First Judicial District of Pennsylvania's ("FJD")
Request for Proposal ("RFP")
For
**Electronic Based Evidence Presentment
Solution**

Dated February 11, 2015

VENDORS' QUESTIONS AND ANSWERS ("Q&A")
<http://courts.phila.gov>

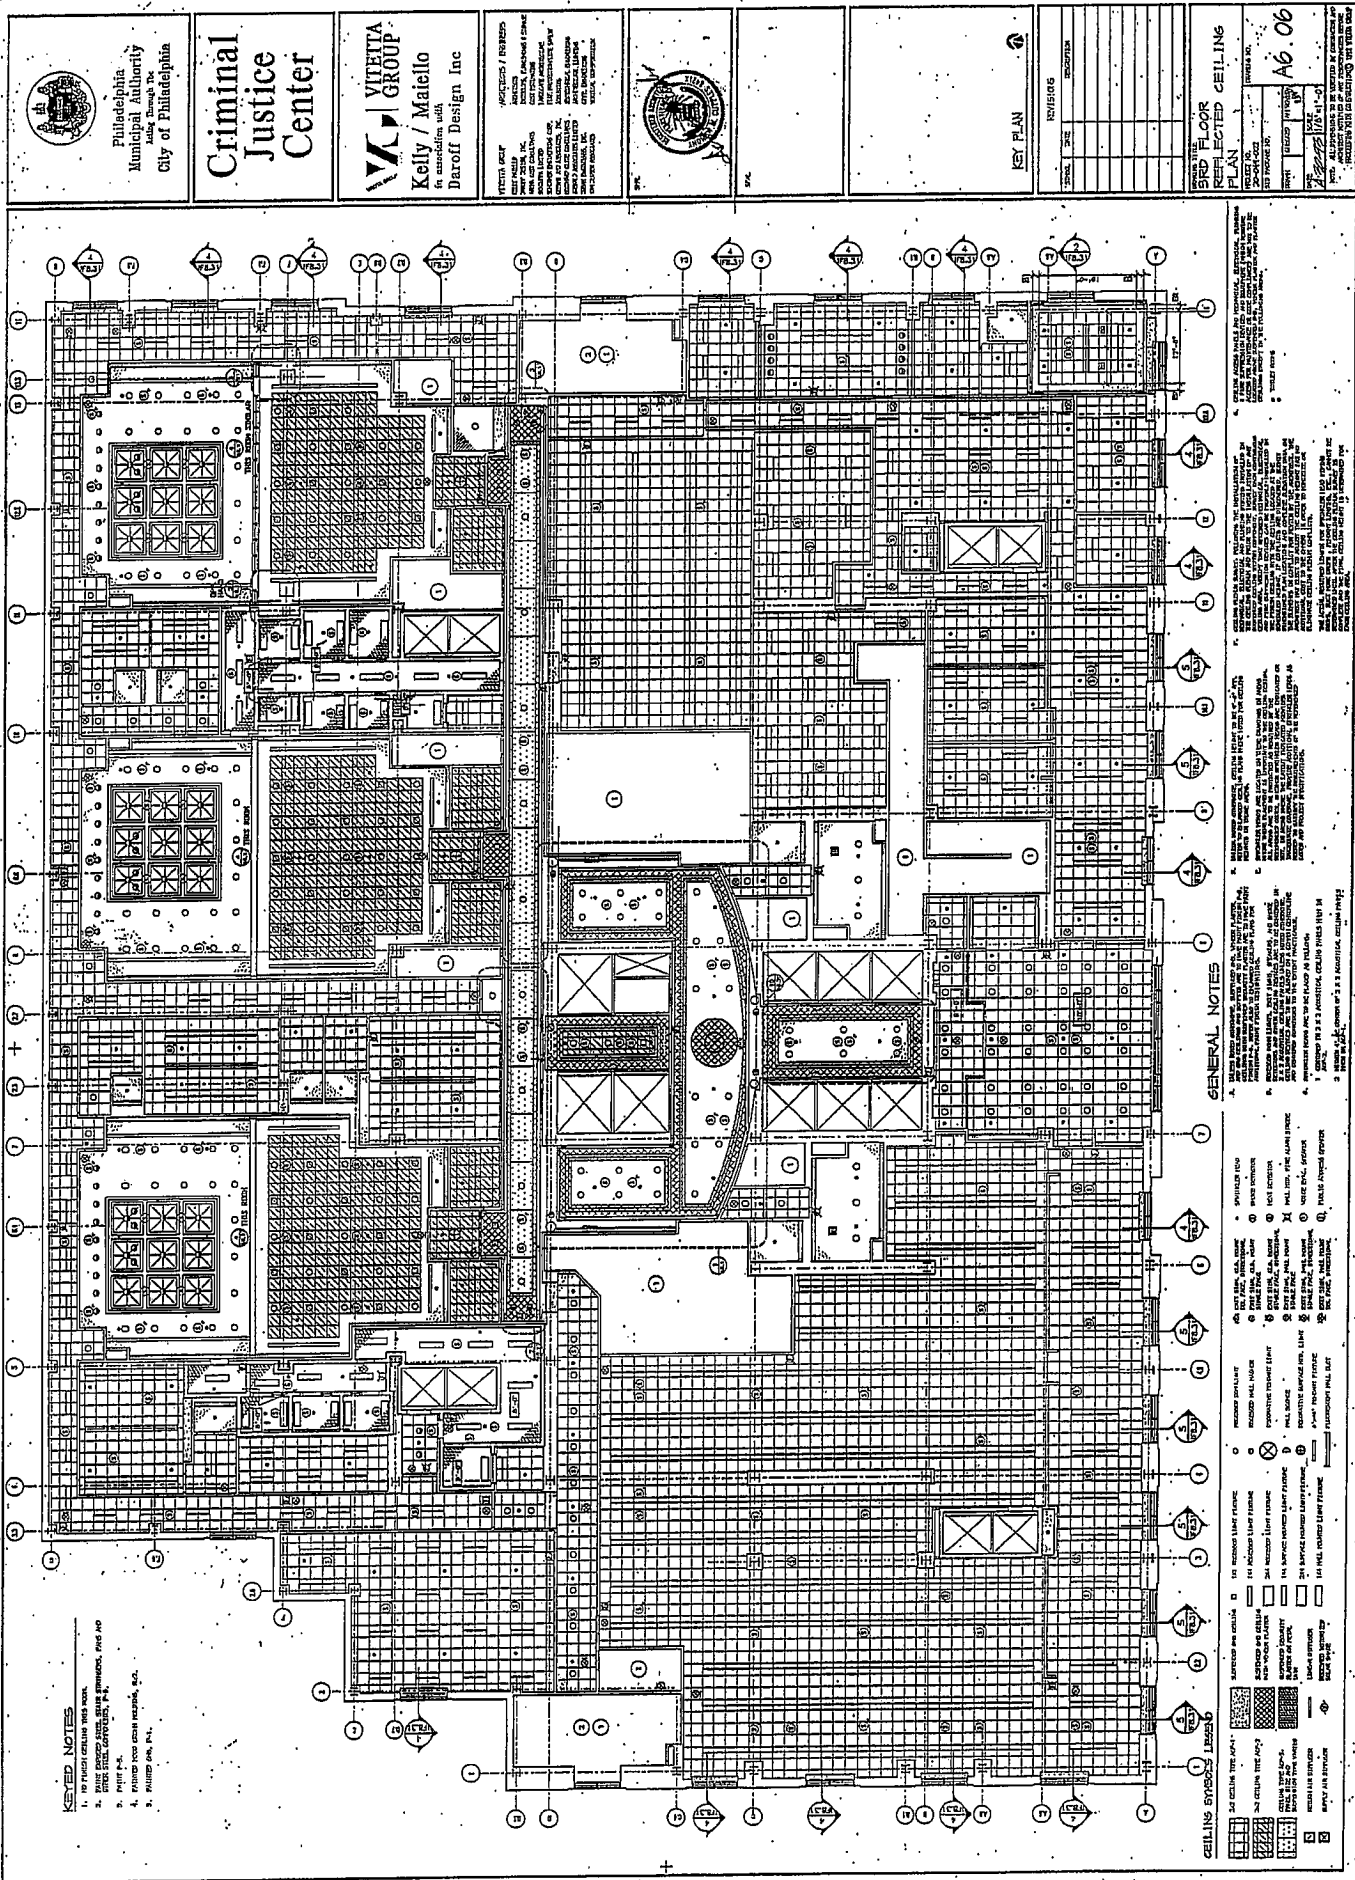
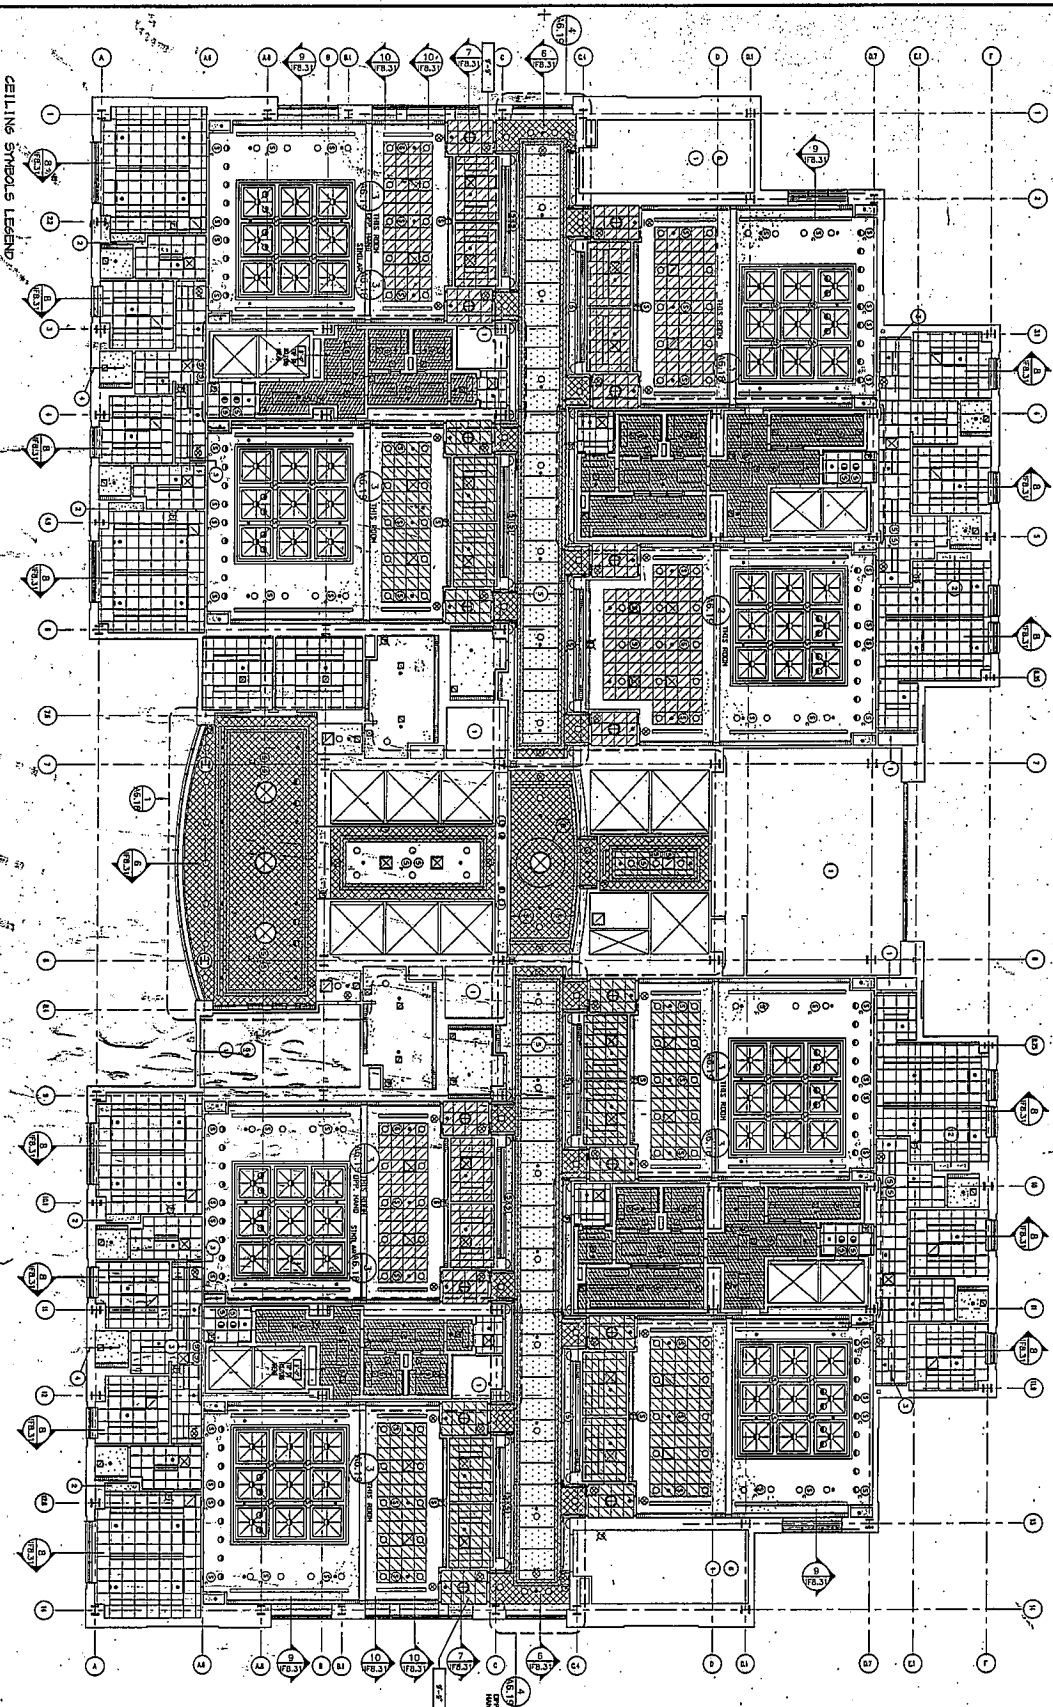
Q25. The FJD stated at the tour that a full floor plan could not be provided, however, would it be possible to obtain a single room layout which would identify doors, windows, and seating locations for just one of the Courtrooms which would be helpful with creating designing options for connectivity?

Q26. Can the FJD supply a reflective ceiling plan for one Courtroom in order to identify projector and recesses screen mounting options from ceiling structure in relationship to positioning of equipment?

Q28. *What is the distance from the ceiling to the deck (open space above ceiling) in the space above the drop/dry walled ceiling within the Courtroom and what is its support structure? (I-beam / Joist/ Truss/ etc)*

See Attachment 1. Attached for your convenience is a list of all applicable courtrooms for this project that includes a short description of each. Also enclosed with Attachment 1 are Reflected Ceiling Plans for the 3rd, 7th, 8th, and 9th Floors.

Also see Q & A #5 above. High profile courtroom 305 - In square 12' 7", to deck 17' 5"; Common courtroom 702 in square 12' 9" and to deck 15' 7". The support structure consists of 2x4 & 2x8 metal studs fastened to the underside of the cement slab above the ceiling.
